CITY OF ALBUQUERQUE

**RE: Circle K – 10850 Golf Course Rd. NW
Permanent Certificate of Occupancy - Accepted
Engineer's Certification Date: 12/15/25
Engineer's Stamp Date: 03/01/24
Hydrology File: A12D008B1
Case # HYDR-2025-00446**

GRADING AND DRAINAGE PLAN

SHEET TITLE:
DETAILED GRADING PLAN

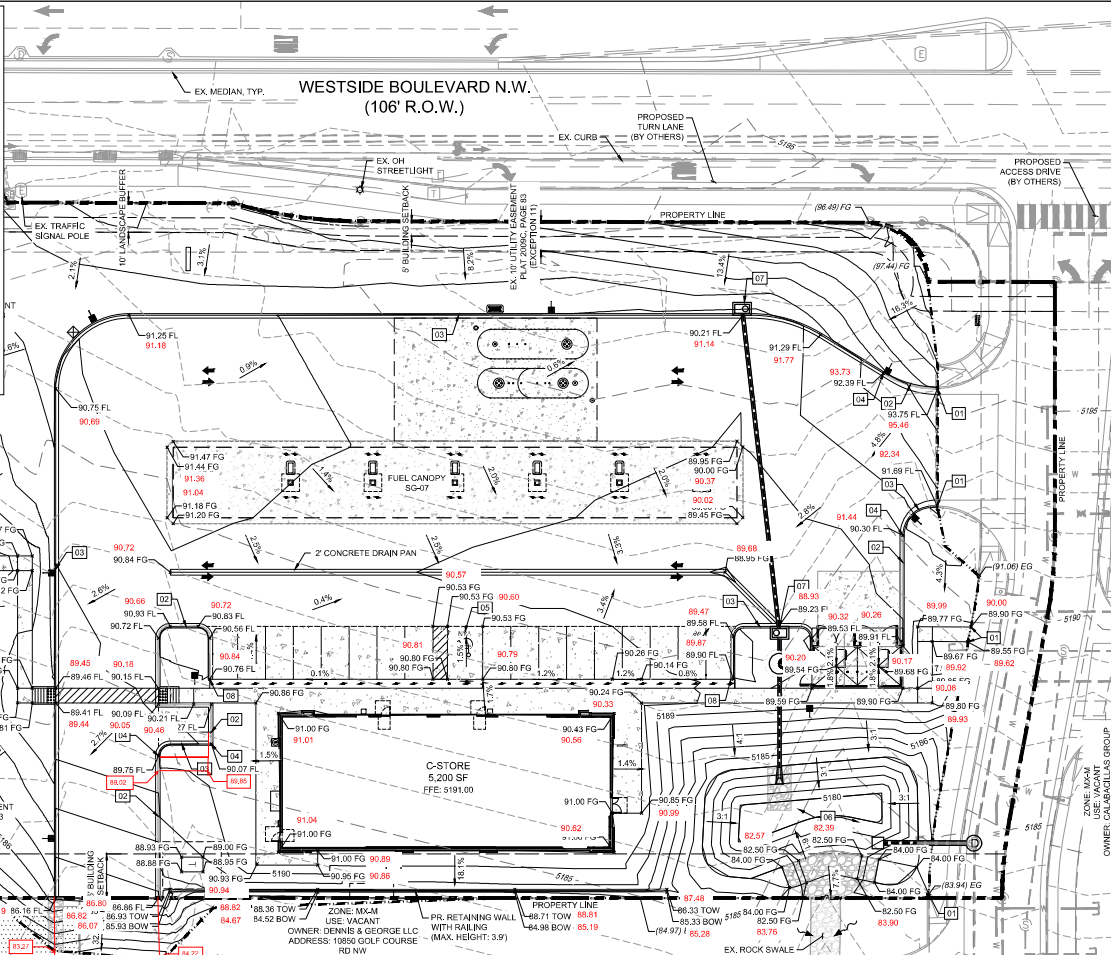
THE TEMPORARY ACCESS DRIVE HAS A LONGITUDINAL SLOPE OF 12.5% WHICH EXCEEDS THE MAXIMUM 10% LONGITUDINAL SLOPE PER THE APPROVED FIRE PLAN. THIS WAS VERBALLY ACCEPTED BY THE FIRE MARSHAL ON 12/15/2025.
